AS-CONSTRUCTED

ROAD AND STORM DRAINAGE CONSTRUCTION PLANS

WEST VILLAGE
RIVER CROSSING

CITY OF MILL CREEK
WASHINGTON

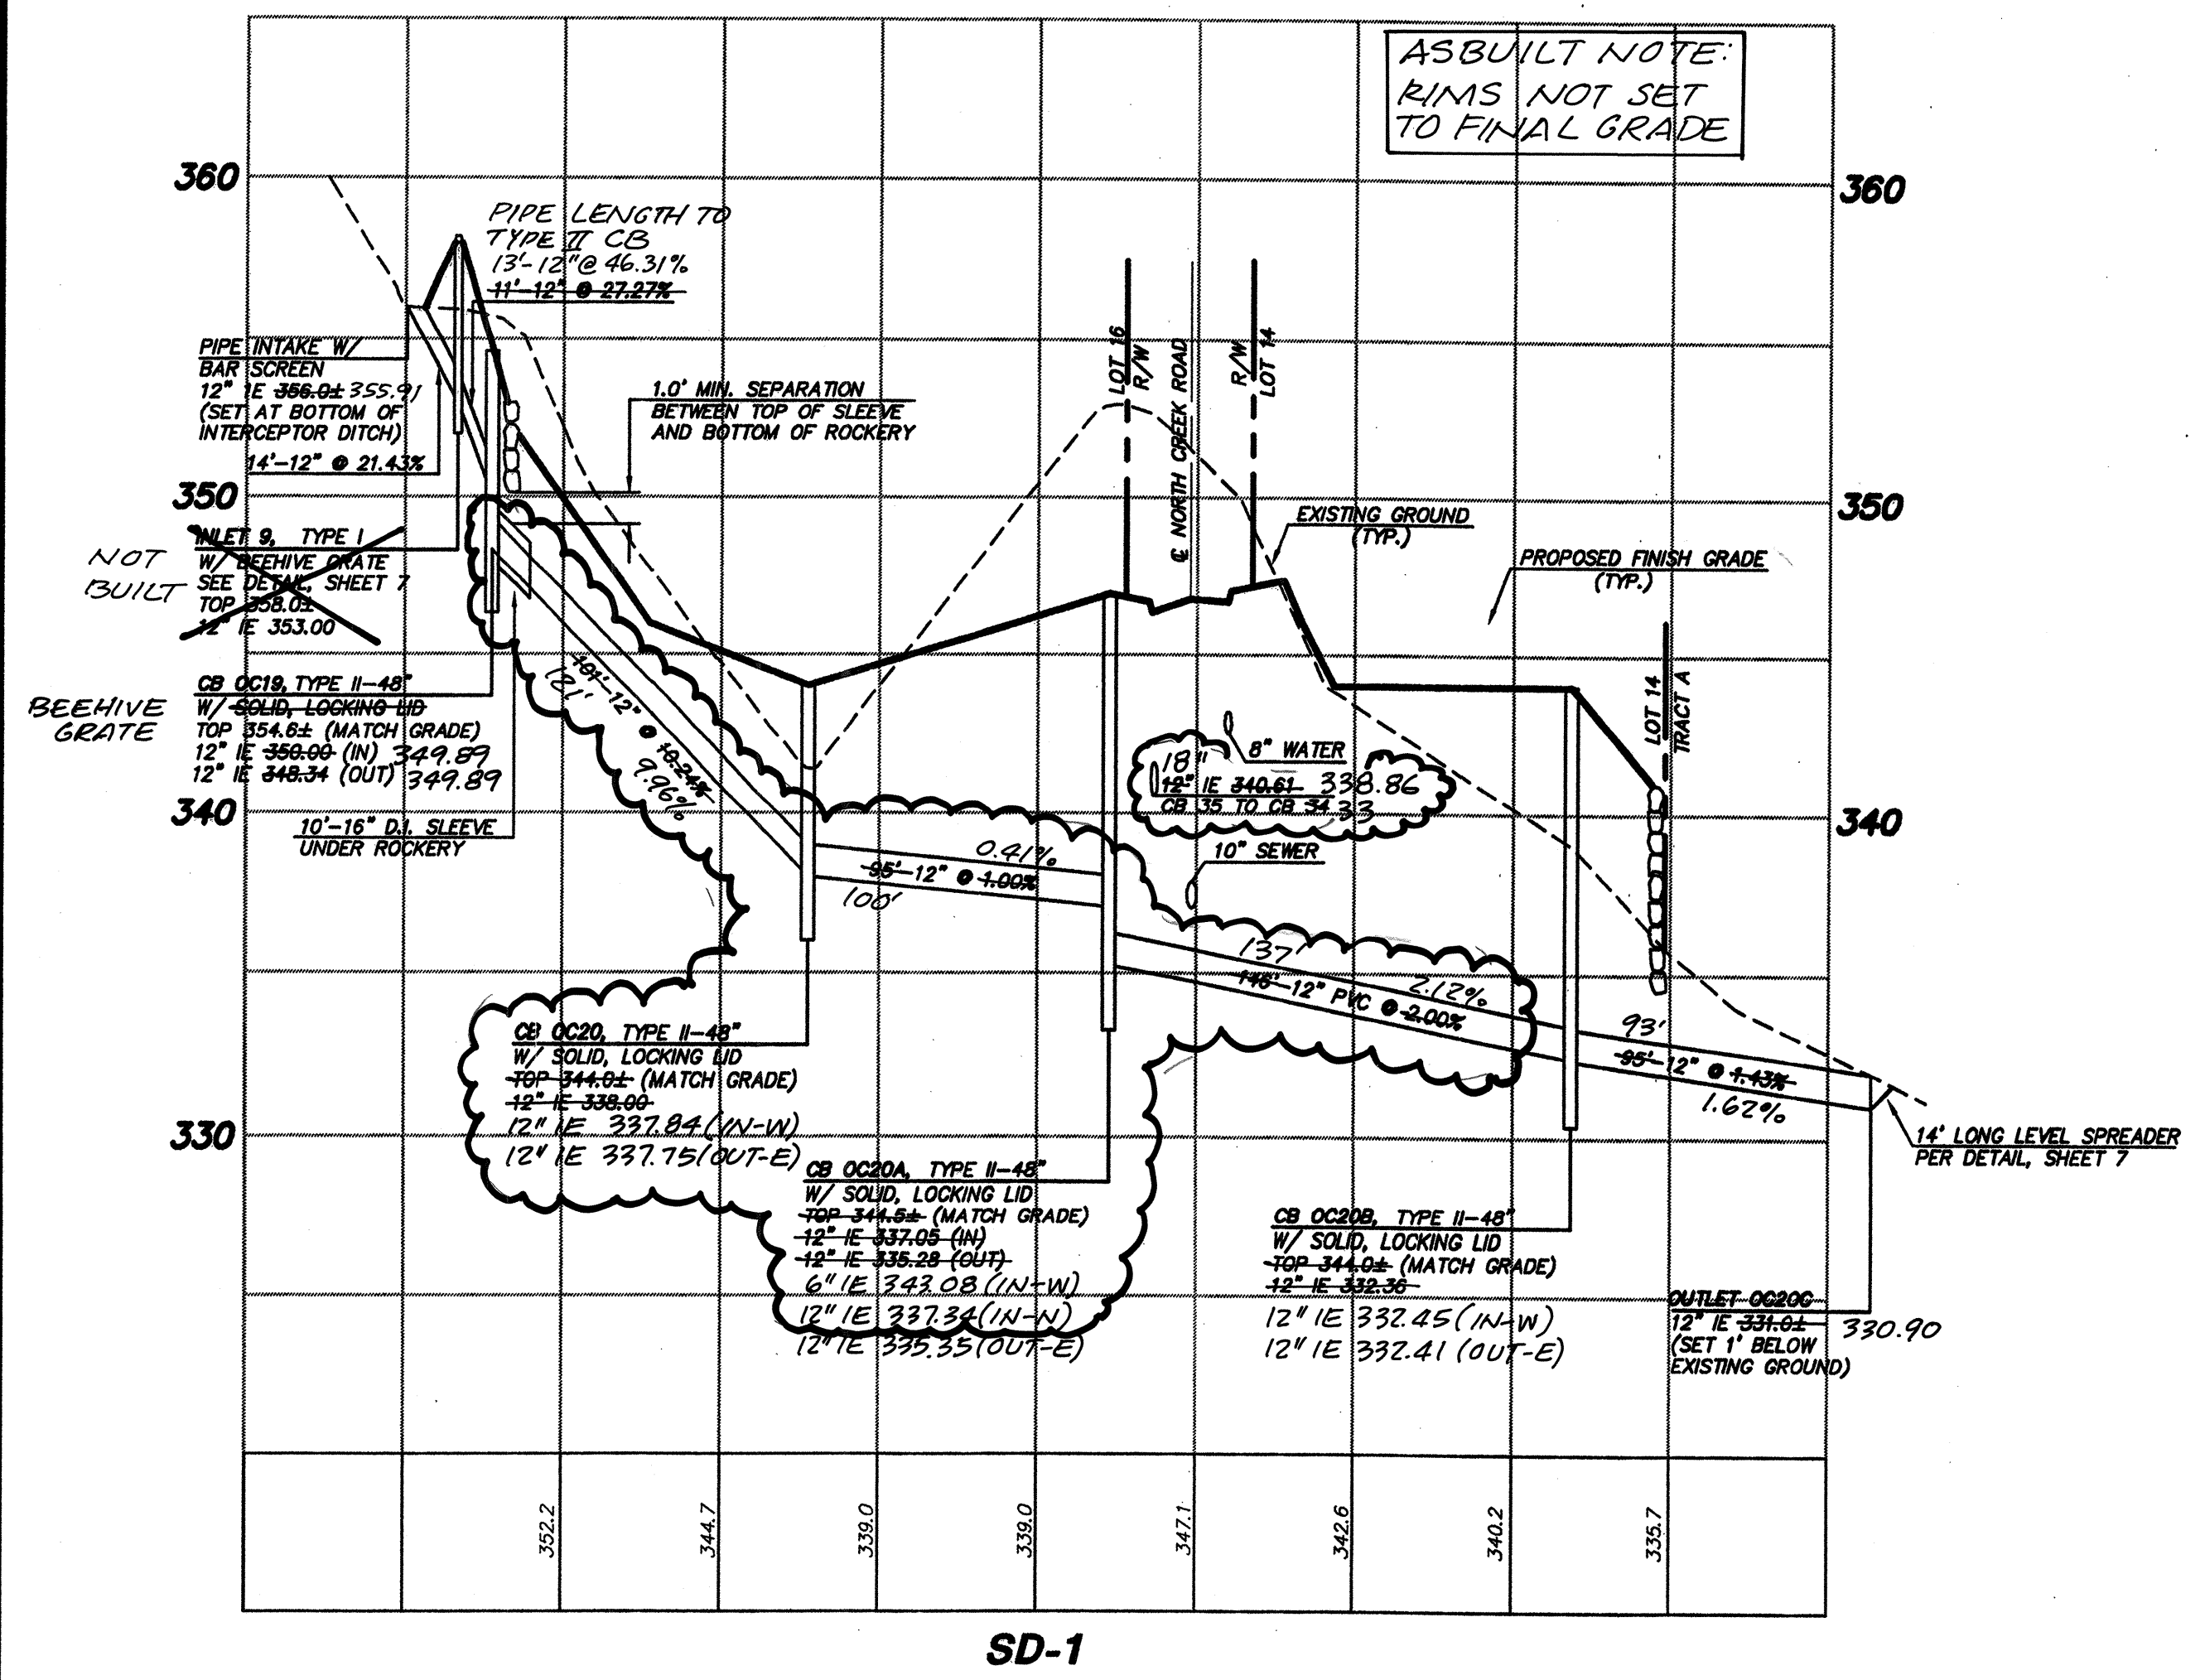
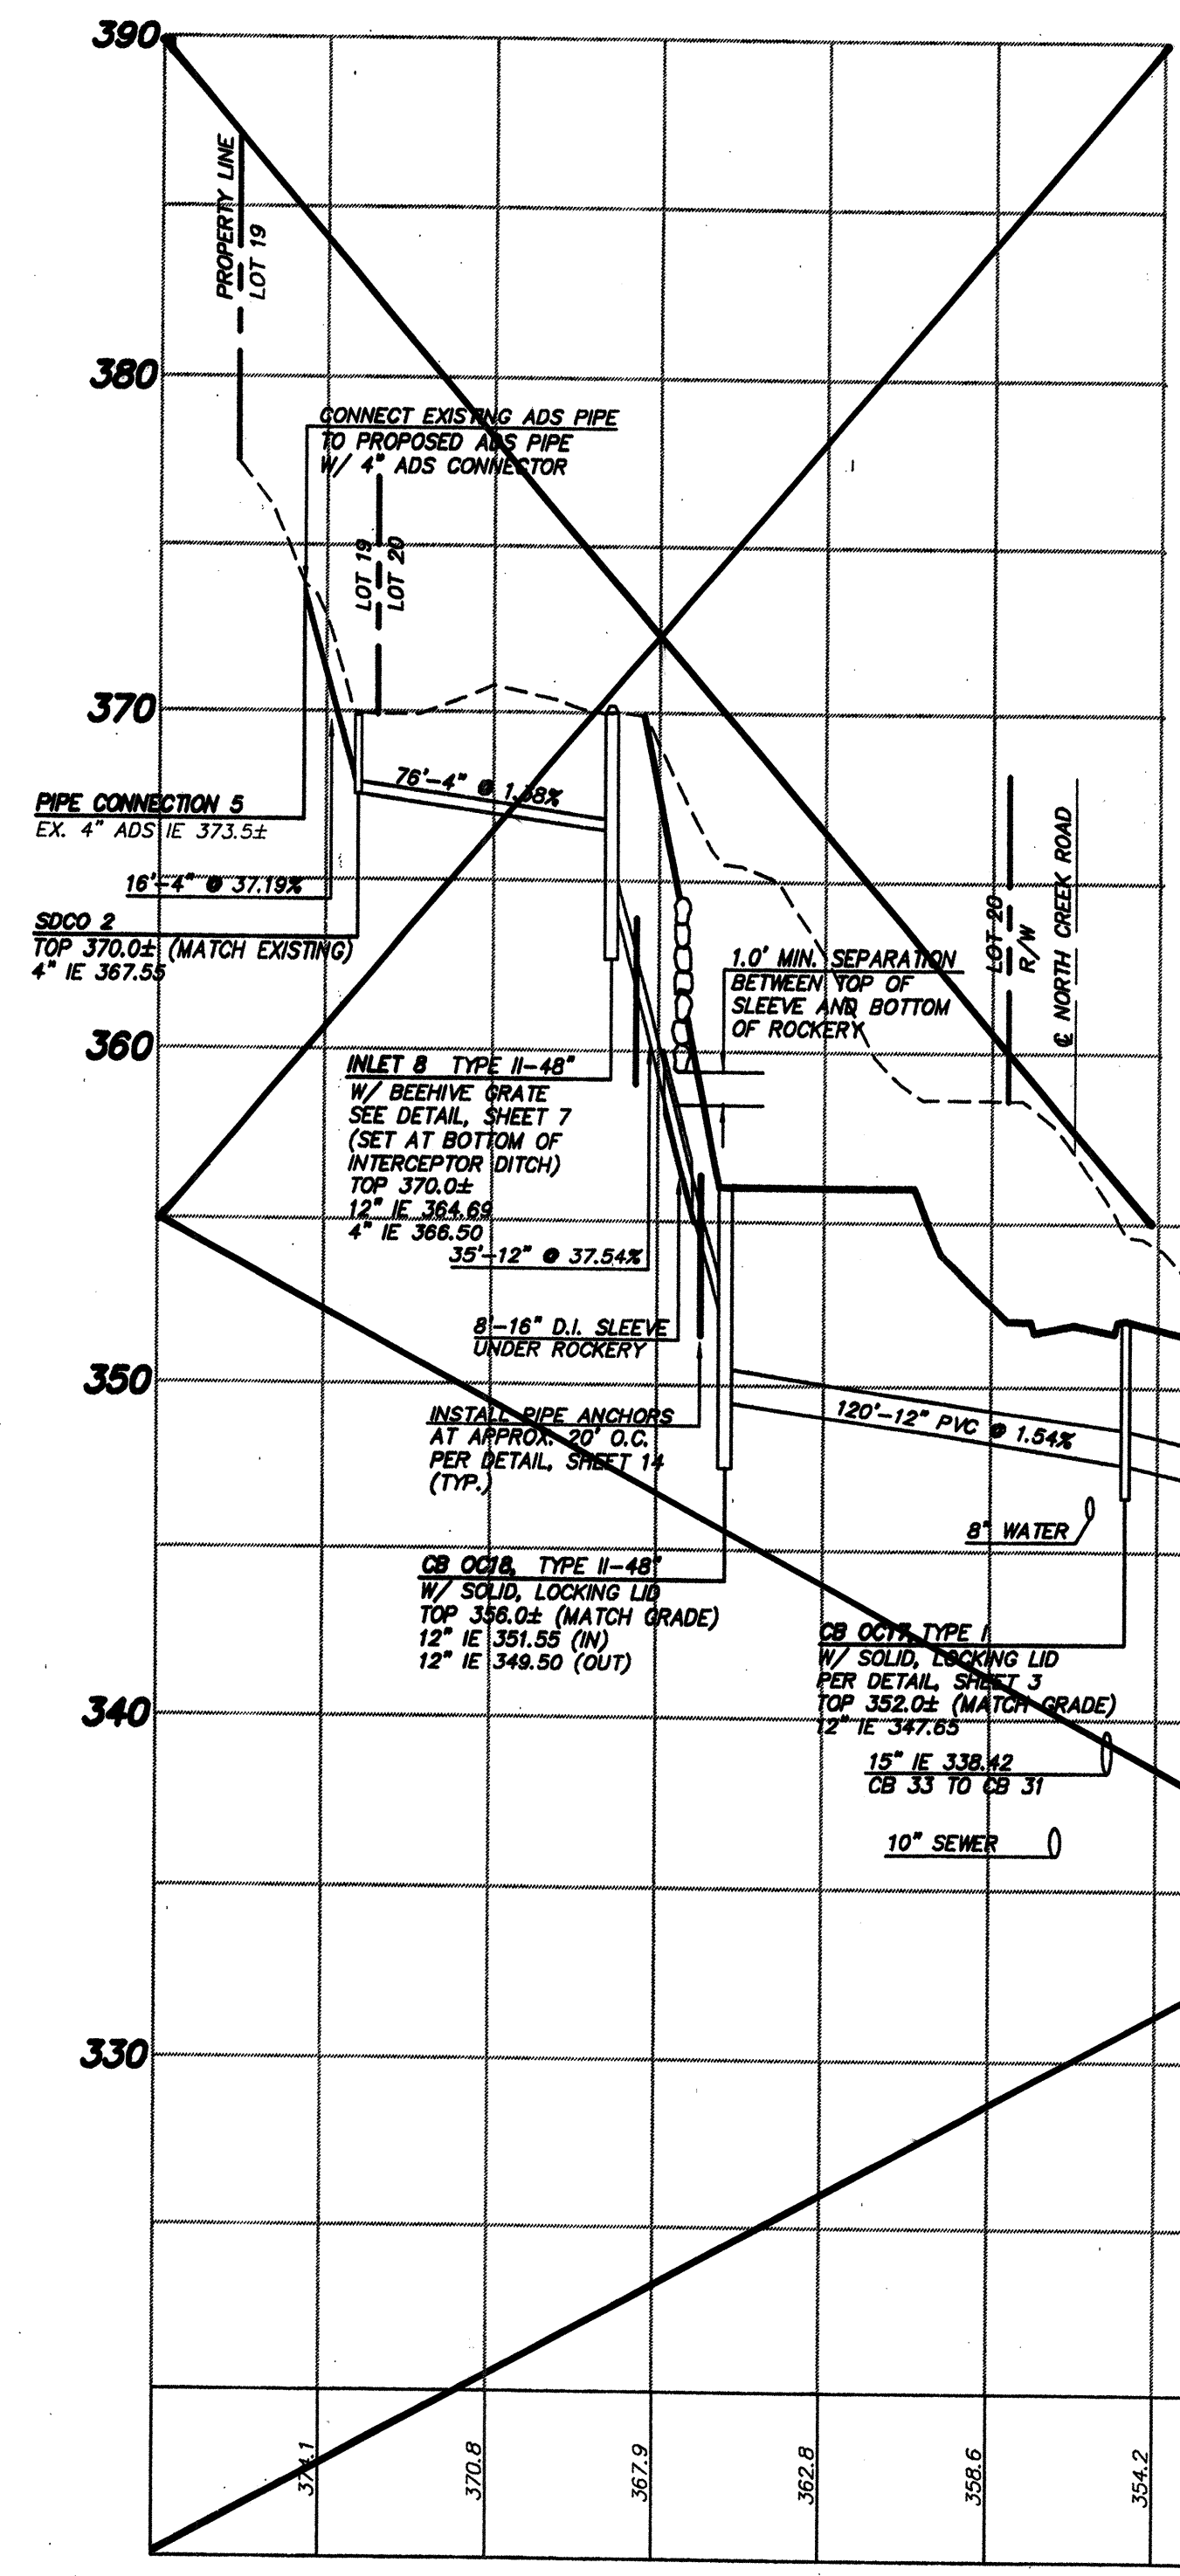
ASBUILT NOTE:
 RIMS NOT SET TO FINAL GRADE
